Statutory Review Design Response

Morland Gardens, London Borough of Brent

Following the receipt of comments from GLA, TFL & Brent Highways on the submitted scheme for Morland Gardens, this document has been produced in order to respond to those comments and show how the scheme has been amended.

1.
Greater London Authority - GLA/5444/01 - 09.03.2020
(GLA Comments)
2.
Transport For London - BRNT/20/7 - 20.03.2020
(TFL Comments)
3.
LBB Highways - D91/1324EP/1 - 25.03.2020
(LBB Highways Comments)

Tree Retention Plan

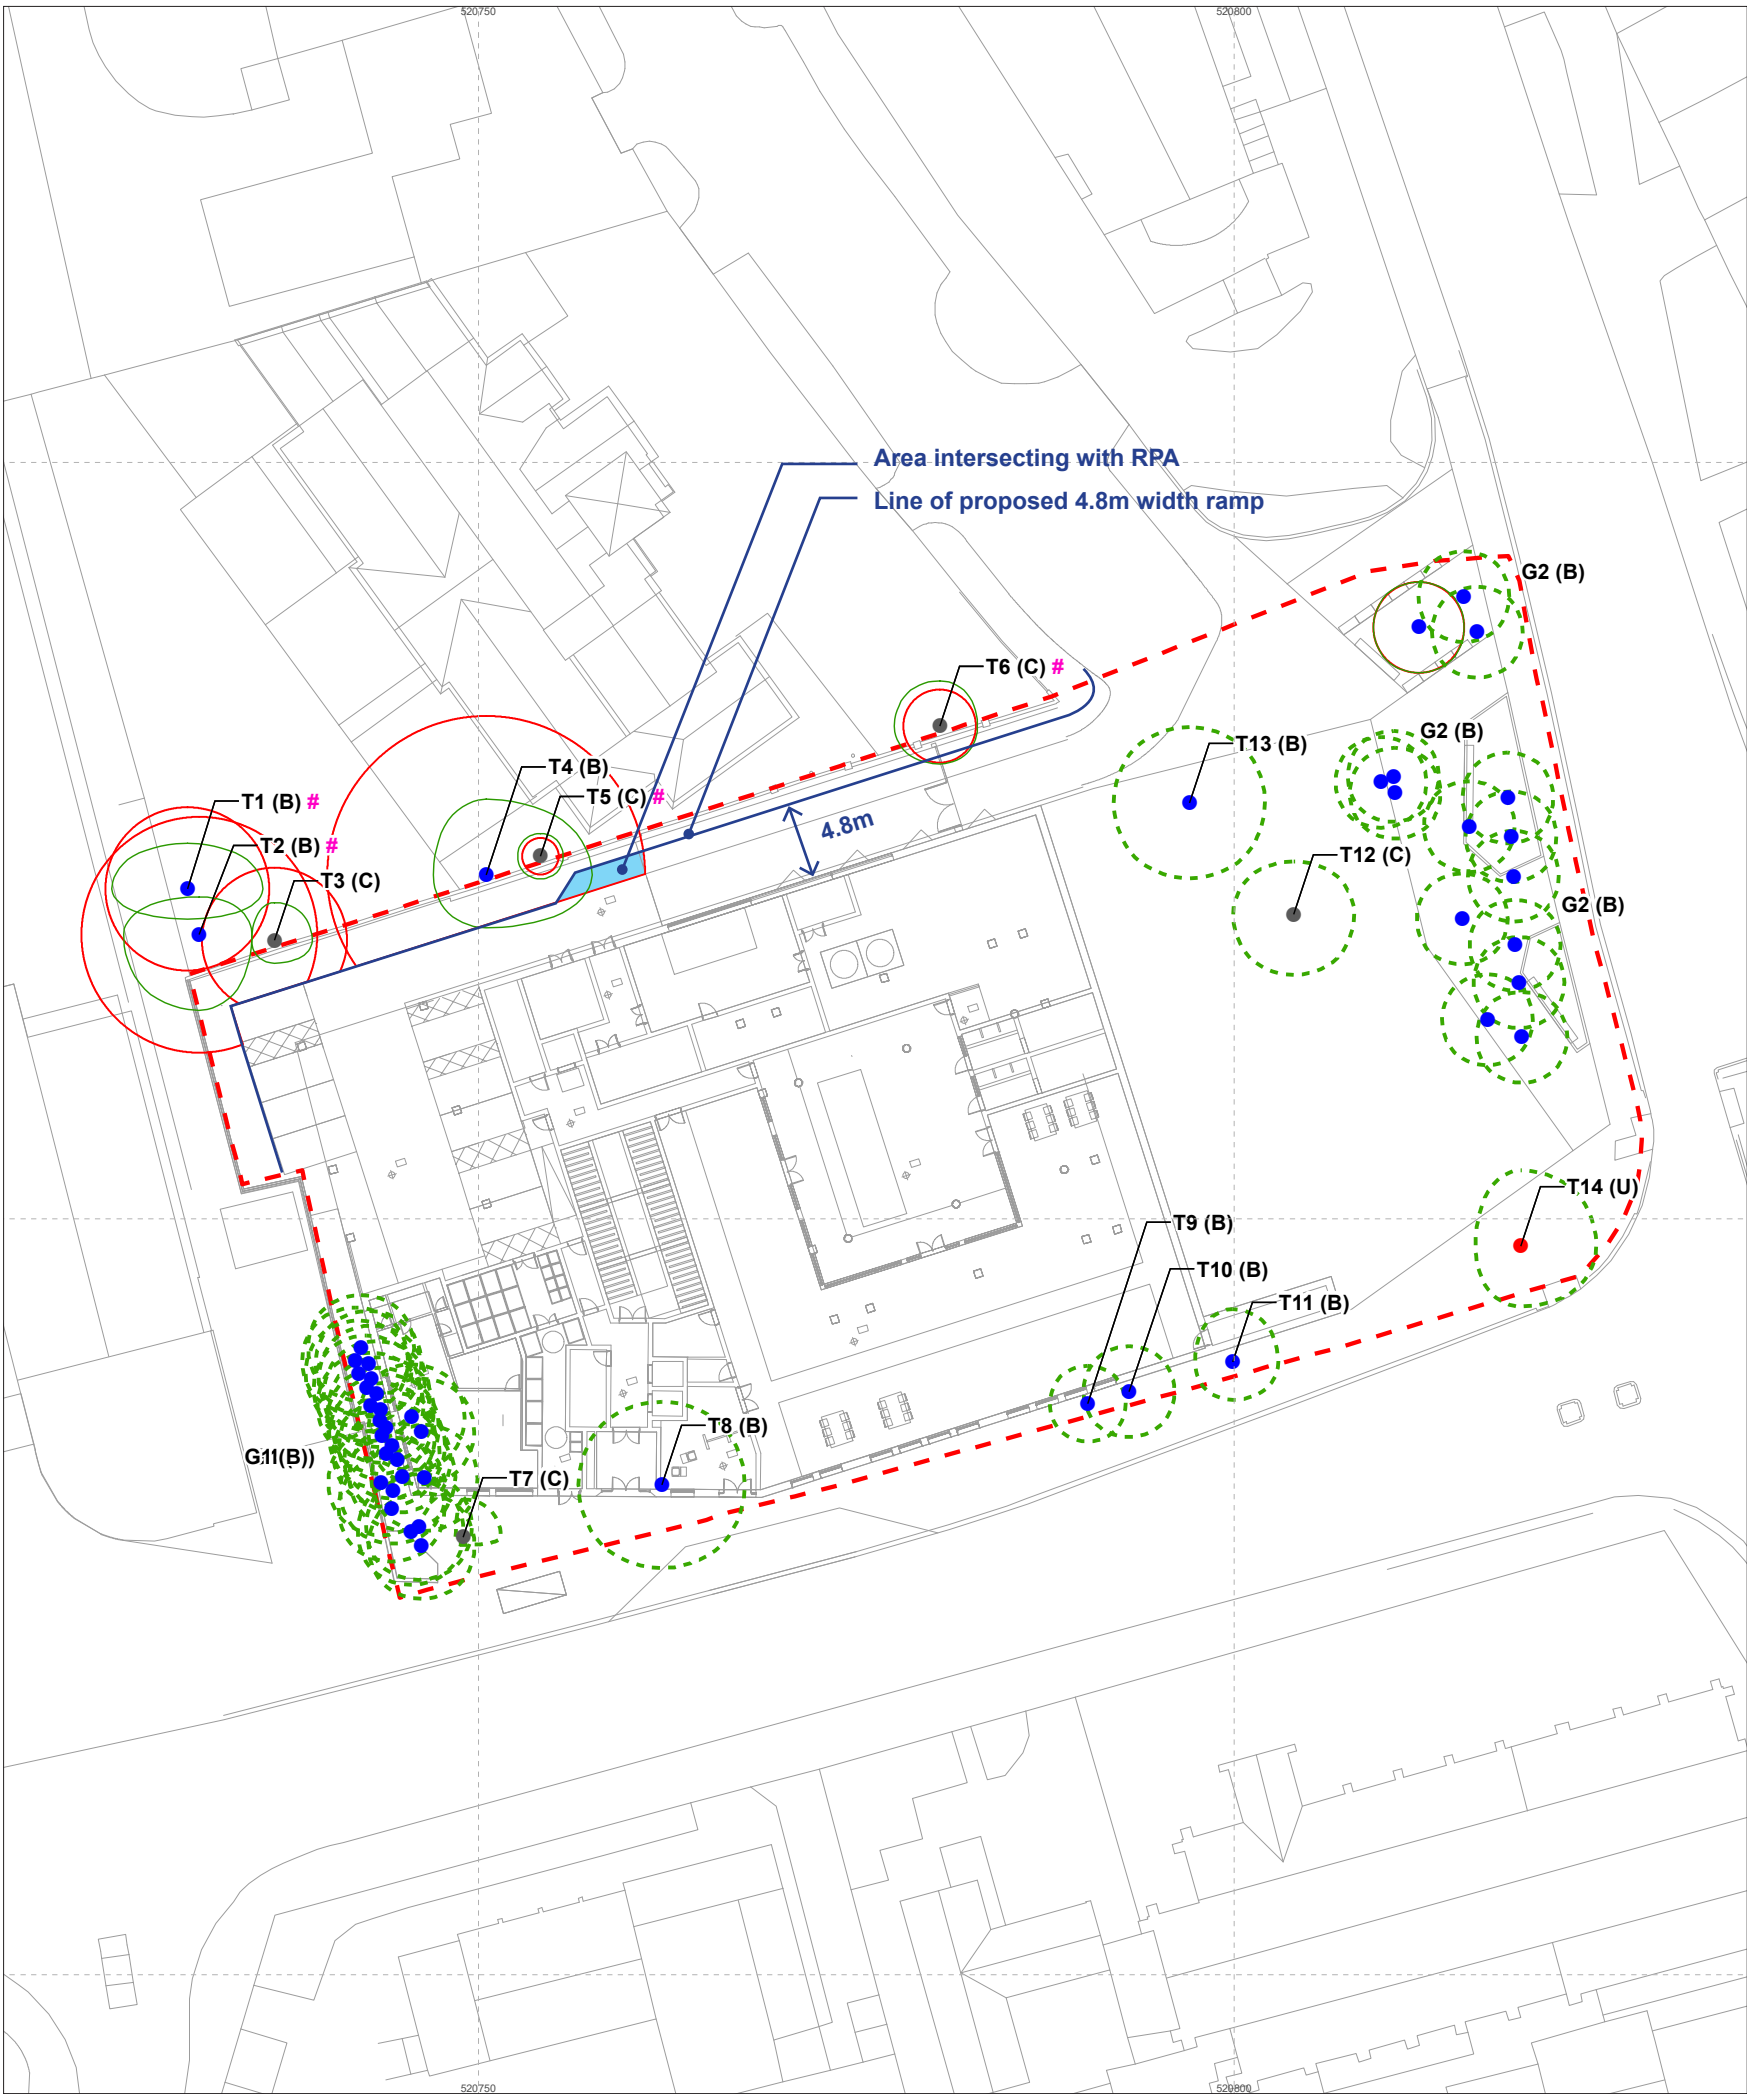
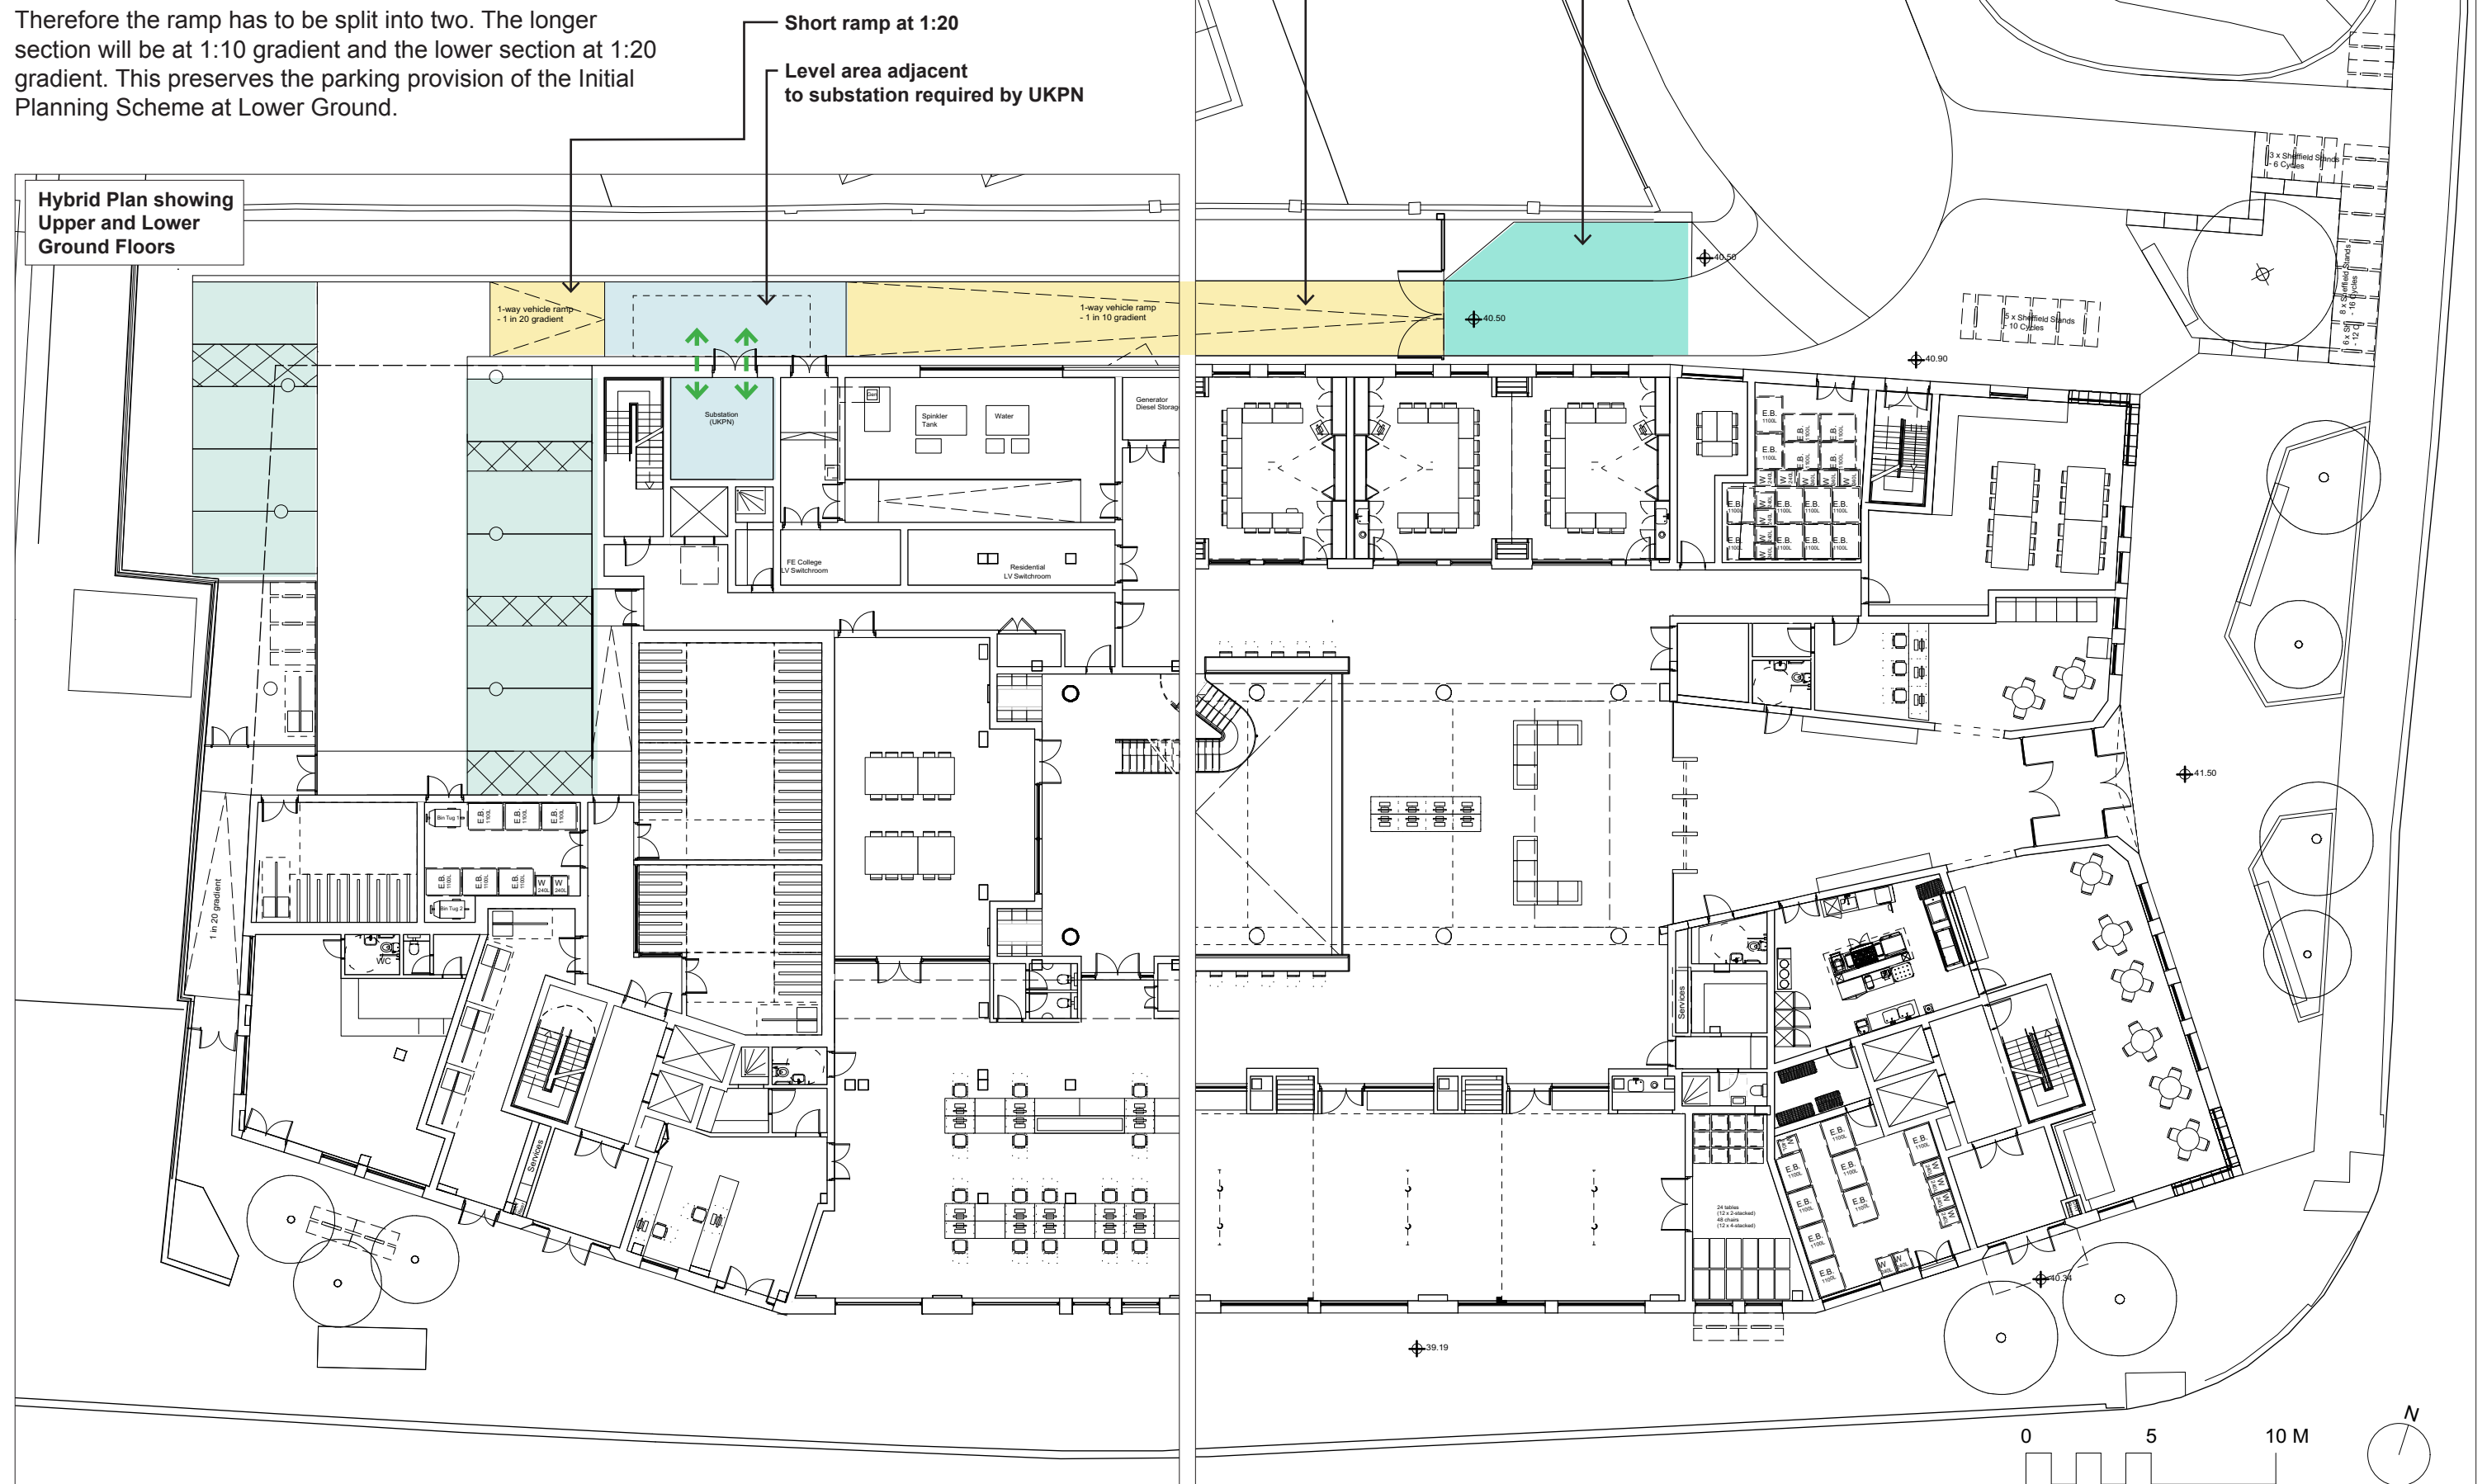
‘the applicant proposes to install a traffic-signal system. However, this still needs to be set far enough into the site for cars to wait and pass one another clear of the highway boundary, as the operation of a private signal-control system that requires traffic to wait in the public highway is absolutely unacceptable, giving rise to issues of liability in the event of a fault to the system or an accident.

It is therefore essential that the access ramp be widened to 4.8m for at least the first 10m from Morland Gardens to provide a passing space between vehicles clear of the public highway....There is sufficient space available between the proposed building and the site boundary to achieve this without affecting the position of the building.’

Having considered the request above by the LBB Highways officer the design team concluded that we would be unable to comply with this request without undermining an Arboricultural Impact Assessment which demands that a 2m offset is maintained from RPAs in this location (See T4 & T5 on drawing).

Positions of roots in this area have been confirmed via scan radars which have been carried out arboricultural surveyors Middlemarch Environmental and the width of the ramp in the Initial Planning Scheme has been determined by this dimension.
